**PROJECT: Lakewood Elementary School
Kitchen Renovation and Freezer Installation**

ADDENDUM 1

ISSUE DATE: March 24, 2023

a) **HOOD SPECIFICATION**

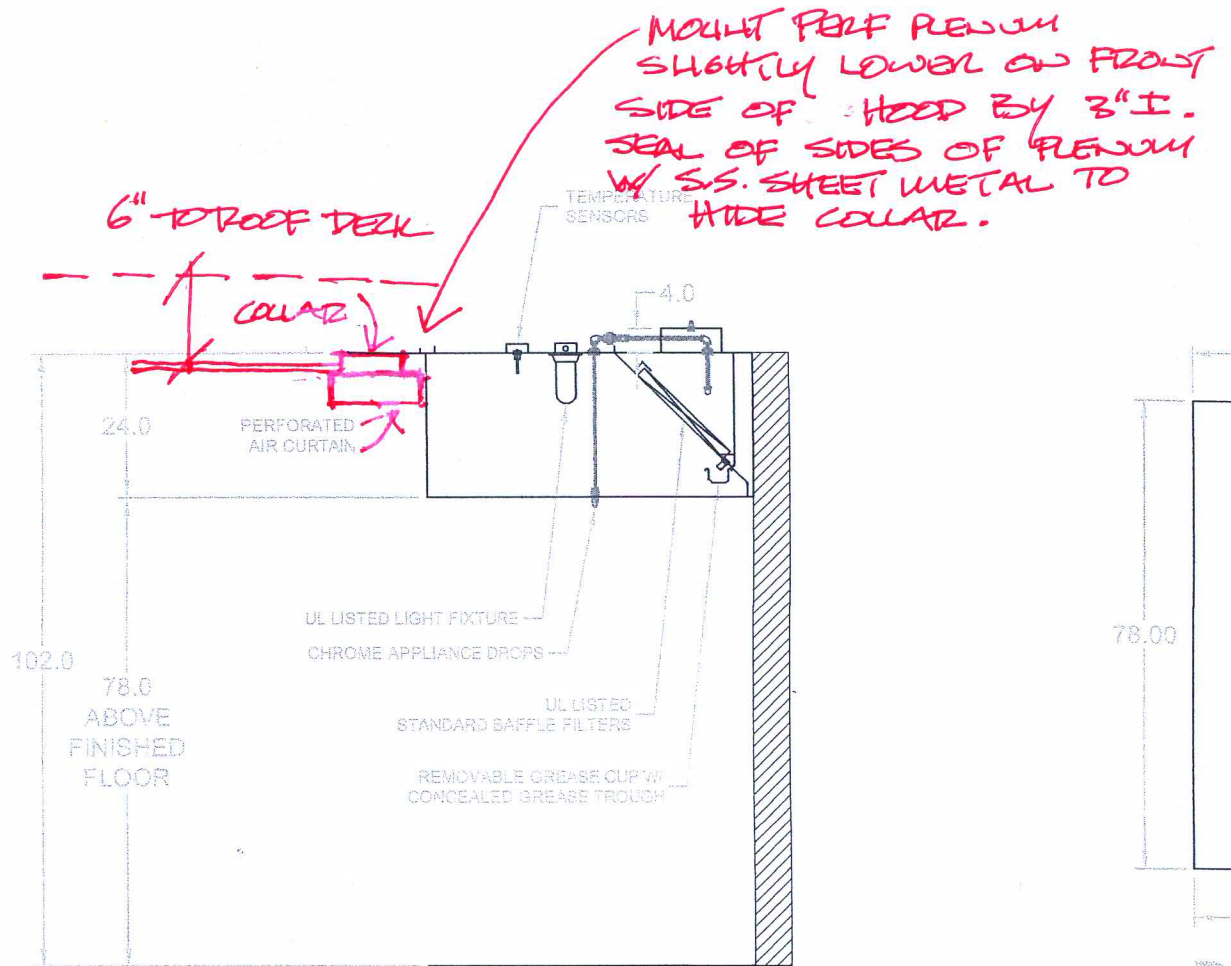
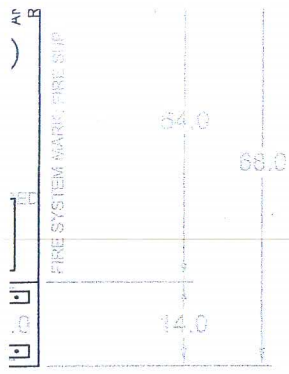
- 1) Control cabinet and fire suppression to be on the left-hand side facing the hood.
- 2) Makeup air unit gas pressure design to be revised to be capable of accepting 6" – 8" WC gas pressure.

CEILING PLAN

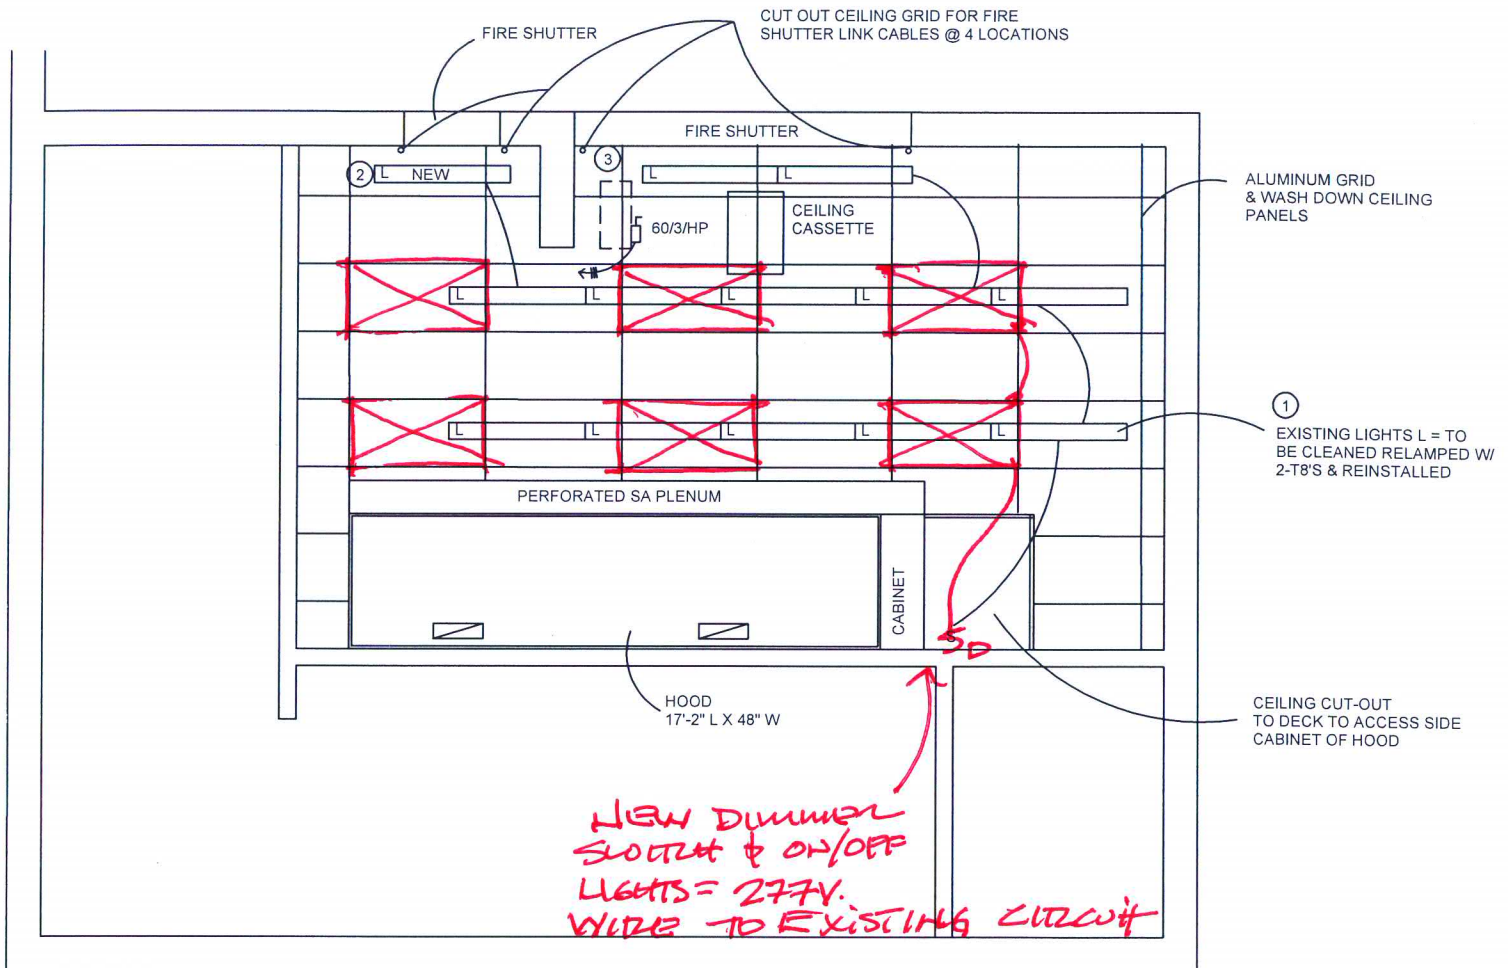
- 1) Provide new 2 x 4 lay-in LED lighting with a dimming On/Off switch. See attached plan.

1. WIRE LIGHTS TO EXISTING 277 VOLT CIRCUIT
2. PROVIDE NEW LIGHT TO MATCH
3. SET DISC SWITCH FOR ROOFTOP CONDENSER & WIRE RUN POWER & COMM. WIRING TO CEILING CASSETTE IN 3/4" C

LIGHTS
 2x4 LAY-IN LEDS
 LITHONIA CPX 2x4
 6000 LM 80 CRI 35K
 A12 MH10 2T W/VOLT
